Application No.: 10/528,354  
Reply to Office Action dated June 13, 2006  
Amendment dated August 10, 2006

**AMENDMENTS TO THE DRAWINGS**

### **REMARKS**

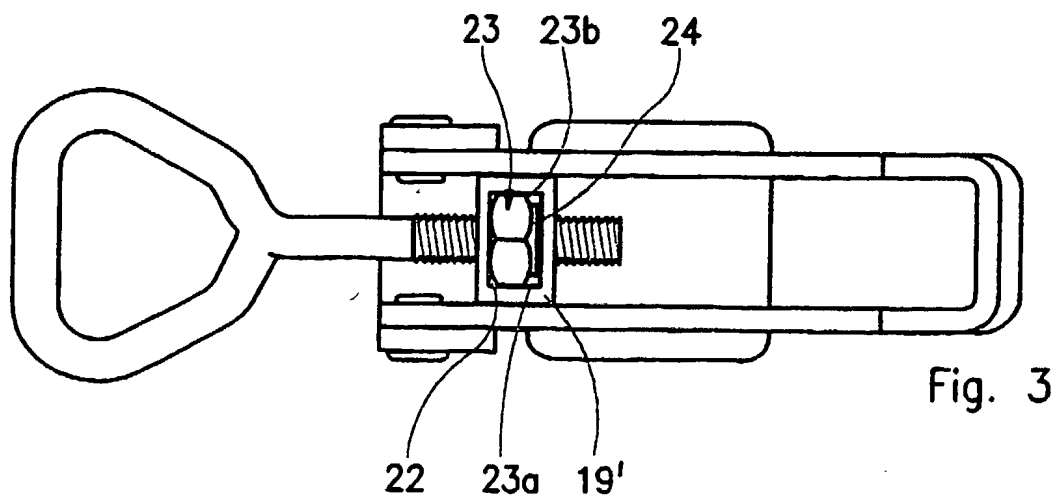
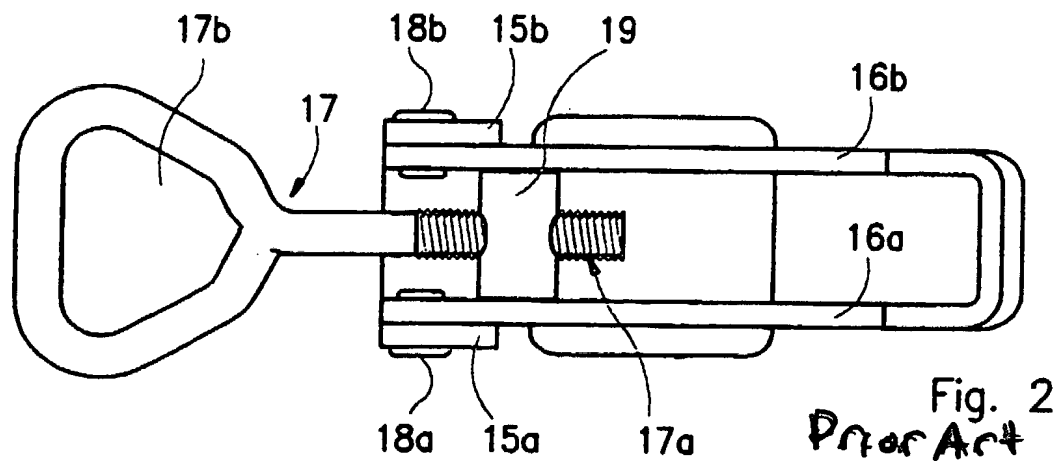
The Office Action also request Figs. 1 and 2 be labeled "prior art." Accordingly, enclosed are amended Figs. 1 and 2 including new labels "Prior Art" as requested by the Examiner.

Fig. 4

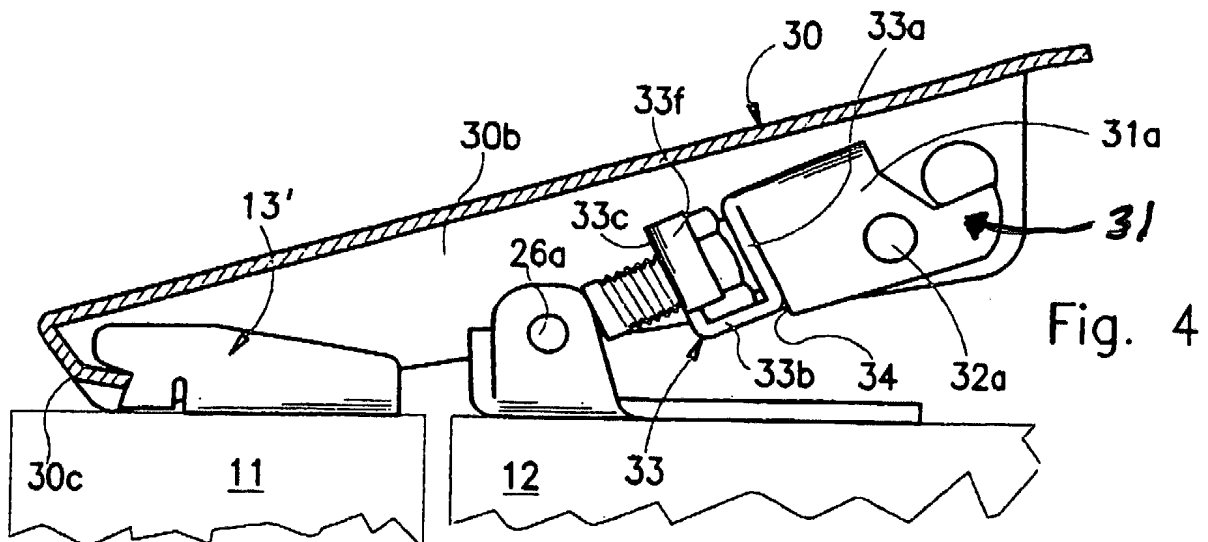
Regarding the objection to the drawings, the Office Action indicates the reference numerals 30a and 31 are not illustrated in the current drawings. It is respectfully noted the enclosed Figs. 4 and 6 have been amended to included these numerals. The Office Action also indicates that element 30b is not described in the specification. However, it is respectfully noted this element is mentioned in the specification at page 7, line 11.
